Integrated Device Technology, Inc.
2975 Stender Way, Santa Clara, CA - 95054

PRODUCT/PROCESS CHANGE NOTICE (PCN)

PCN #: **A-0412-04** DATE: 12/15/2004

Product Affected: All Green Products

Before Change (example)

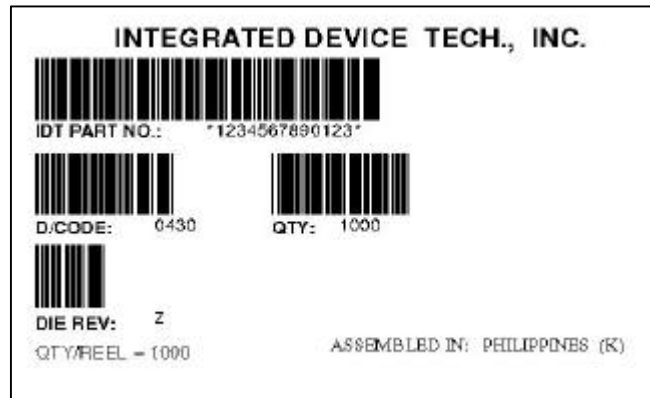
Add Pb-free words, category and maximum safe operating temperature to IDT standard bar code label.

After Change (example)

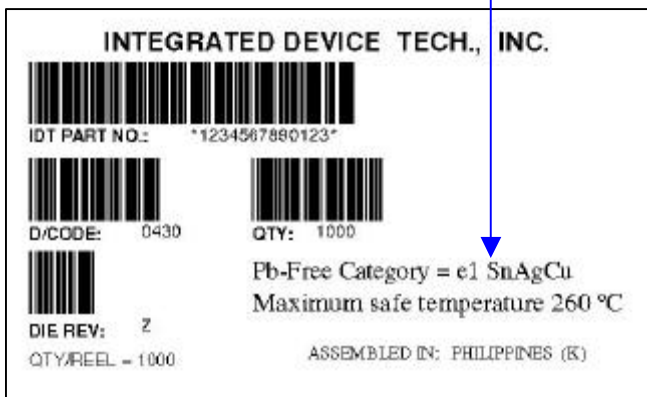
Pb-free category = e1 SnAgCu (BGA packages)
and maximum safe temperature

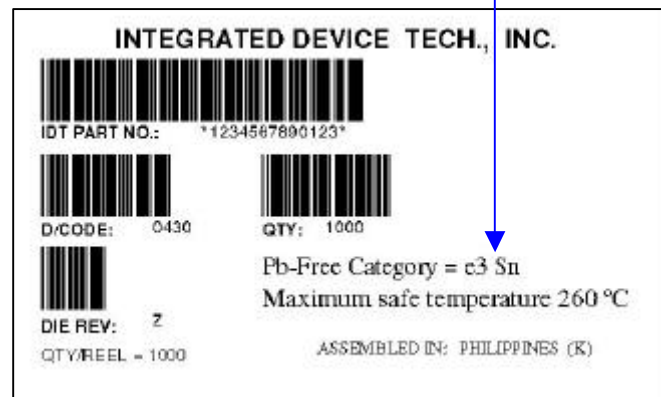
Pb-free category = e3 Sn (lead frame packages)
and maximum safe temperature

Attachment 2: (Customer specific)

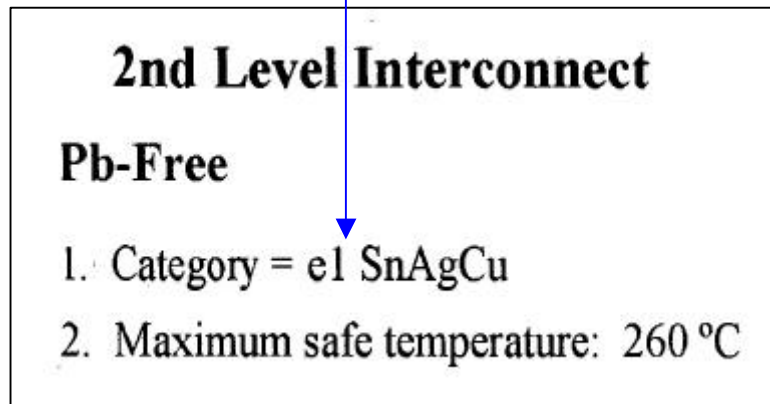
Add an additional 2nd Level Interconnect label consisting of Pb-free words, category and maximum safe operating temperature.

Category = e1 SnAgCu (BGA packages)

Category = e3 Sn (lead frame packages)
